CPCC ENGINEERING PACKAGE

EP No: ECR-25-001621 Rev 01

EP Title: MO720 and MO721 New Roof Installation

MO721 Construction Sketch, SK-01

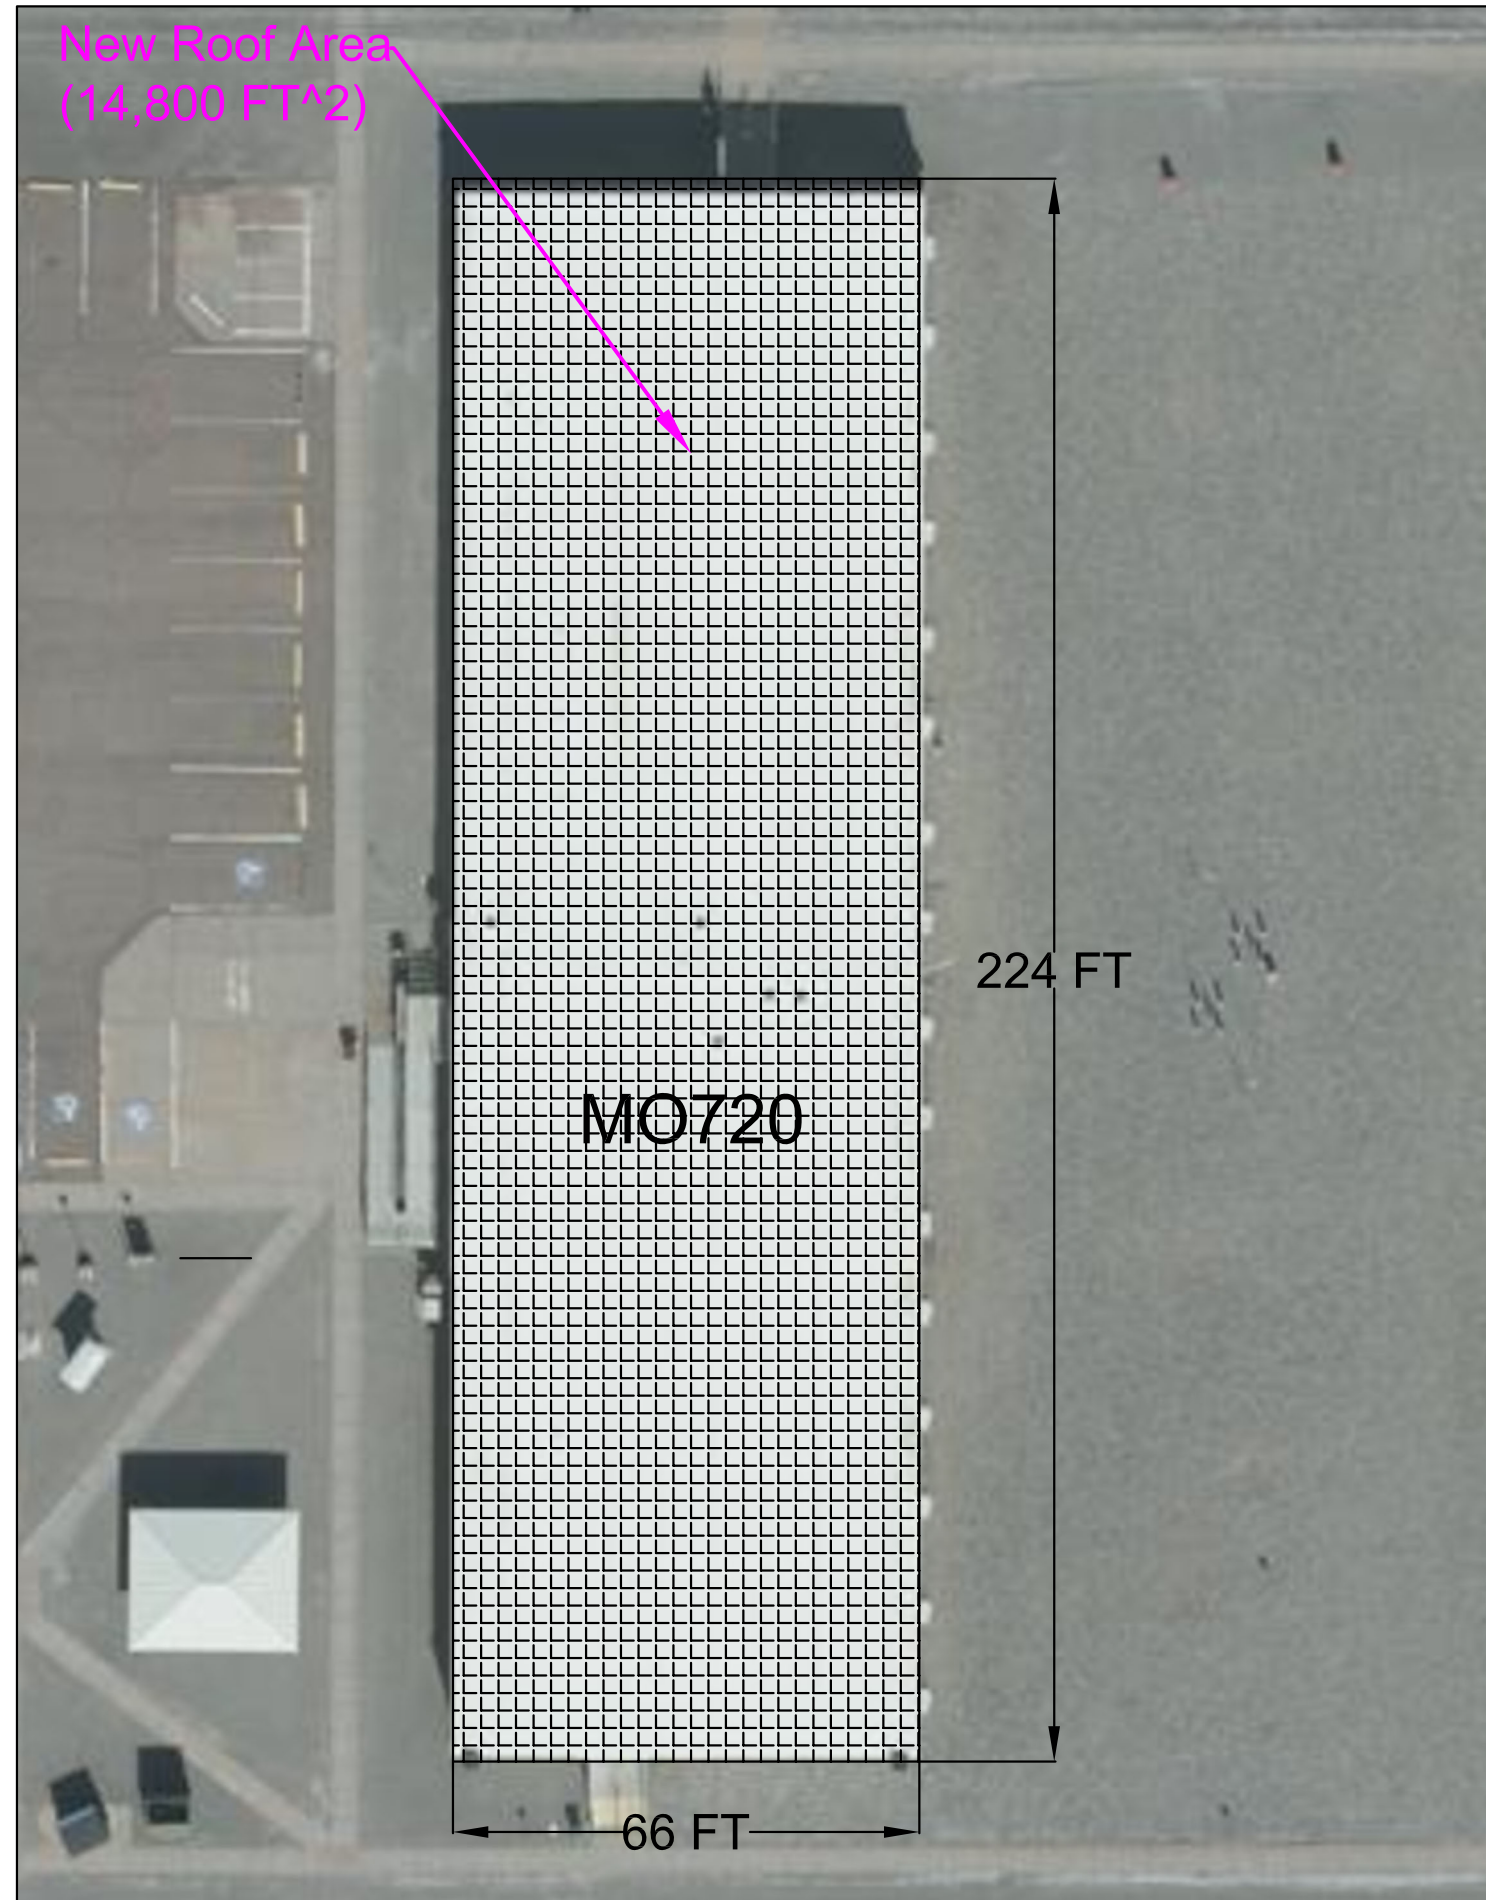
Requires 90-mil membrane to be installed as indicated on construction sketches, SK-01 & SK-02.

- Remove all existing roof membrane and associated equipment/material for installation of new roof membrane and other associated material.
- Following the removal of the existing membrane, the contractor shall perform a visual inspection of the sheathing and ensure there is no damage prior to installing of the new membrane on the roof.

- Ensure that the existing roof structure plywood sheathing remains undamaged during the removal of the existing membrane.
- Upon roof surface fully prepared for installation of new roofing, install roof materials per manufacturer's specifications. 90-mil membrane is required to be installed. See VI-01, Sh 1.

- Roofing material is to be applied on entire roof area, approximately 3,700 square feet.
- All construction loads on the roof shall NOT exceed the roof design live load of 30psf (30 lbs/ft²). See current Good Faith Roof Assessment for recommendations.

- If more than 300 lbs concentrated point loads are to be placed on the roof, the contractor is required to install wood planks to distribute the load evenly; however, the distributed load shall NOT exceed 30psf.
